#00-02-35-003N: Clunking Noise Under Hood and Can Be Felt in Steering Wheel and/or Steering Column (Replace Upper Intermediate Steering Shaft (I-Shaft) Assembly) - (Mar 26, 2008)

This bulletin is being revised to add diagnostic information (refer to Diagnostic Tips) to check the lower steering column bearing as a potential source of the noise. Please discard Corporate Bulletin Number 00-02-35-003M (Section 02 -- Steering).

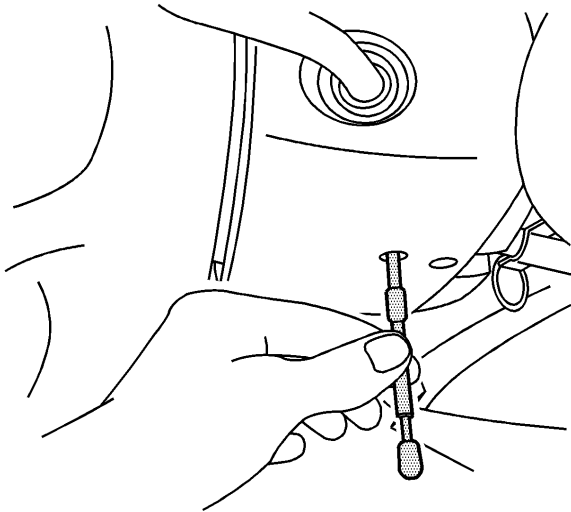
DO THIS	DON'T DO THIS
Replace the I-Shaft with P/N 19153614.	Do NOT lubricate or exercise the I-Shaft.

- I-shaft P/N 19153614 has been designed to replace previous designed dampened and non-dampened I-shafts. The physical difference in the yoke size will accommodate all vehicles listed in this bulletin.
- Due to the design of the new I-shaft, it is not possible to lubricate/grease the I-shaft.
